**Title:** **Correction on indicators**

| **25.211** | CR | **072** | Current Version: | 3.3.0 |

| **Subject:** | Correction on indicators |

| **Clauses affected:** | 4.2, 5.3.3.6, 5.3.3.7 |

**Figure 21: Structure of Acquisition Indicator Channel (AICH)**

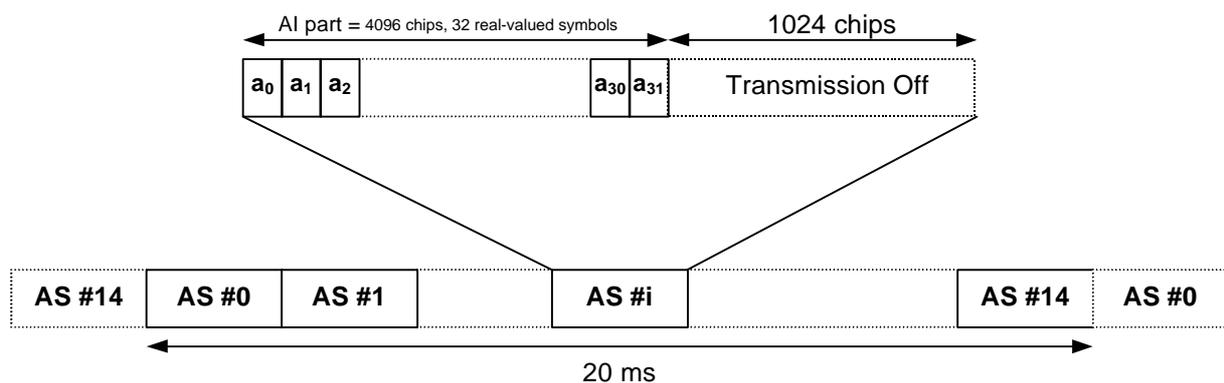
If an Acquisition Indicator is set to +1, it represents a positive acknowledgement. If an Acquisition Indicator is set to -1, it represents a negative acknowledgement.
